TECHNICAL SERVICE BULLETIN

reissue No.LTB00406v2/2012

Subject/Concern:	Heating Ventilation Air Conditioning Evaporator (HVAC) Temperature Reading Inaccurate - Evaporator Freezes		
Model:			
Defender (LD)	Year: 2007-2012 VIN Range: 7A732615- CA414266

E139217

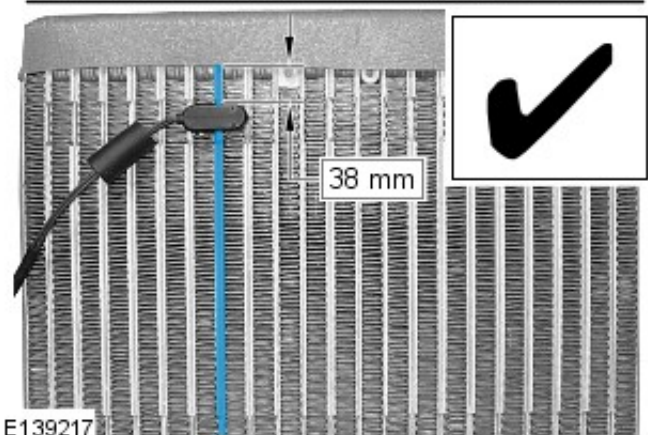
Only Sensors with the Yellow Identification stickers must be used. Sensors with either white or Green stickers attached must be returned to Land Rover Parts and not be used.

See graphic EI39217 for the new type of the HVAC evaporator temperature sensor and the correct position for it to be fitted.

Install a new HVAC evaporator temperature sensor.
